**ERF 2433, No 55 STELLA ROAD, MONTAGUE GARDENS: PROPOSED ESTABLISHMENT OF A CREMATORIUM –
DRAFT BASIC ASSESSMENT REPORT AND AEL
(DEA&DP REFERENCE: 16/3/3/1/A1/20/3027/22)**

The draft Basic Assessment Report (DBAR), submitted under your cover letter, dated 11 July 2022, pertaining to the abovementioned project, refers.

FIGURE 3: Current water consumption of Erf 2433, Montague Garden being 2.88kl/day

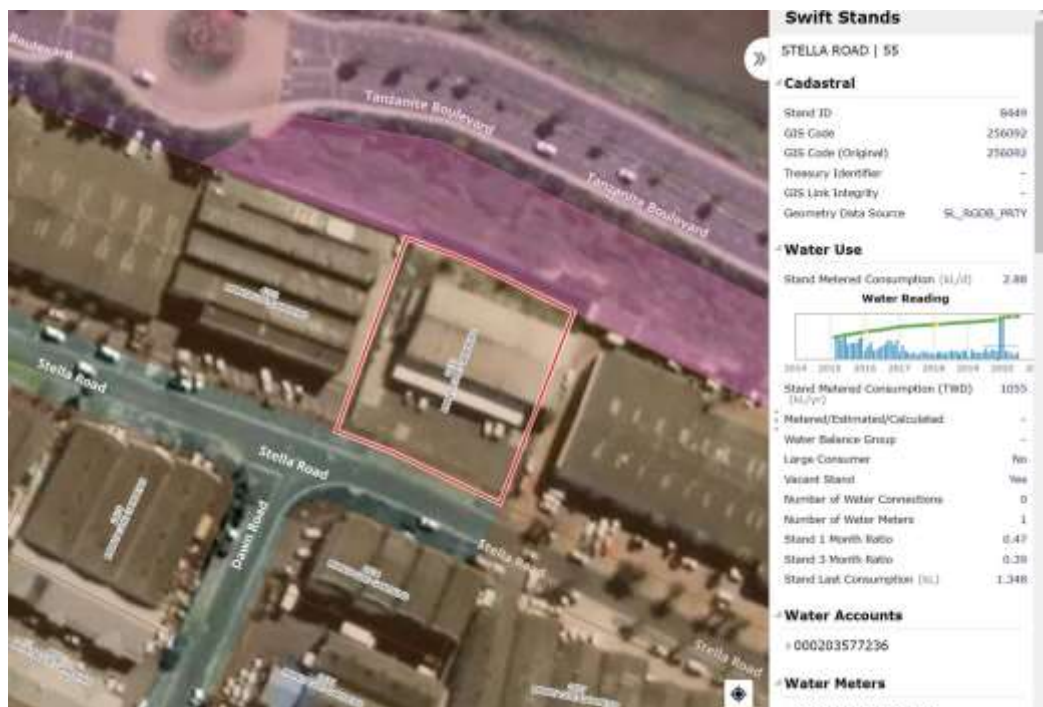
The site is served by a 200mm water supply at a peak pressure of 59m. The current water consumption of the property to be redeveloped is 2.88kl/day as reflected in the Figure 3 data below.

- 6.6 **Water Demand Management Branch's Conclusion:**
- 6.6.1 Provided the water consumption is below the 2.88kl/day for the proposed redevelopment water and sewer capacity could be accommodated.
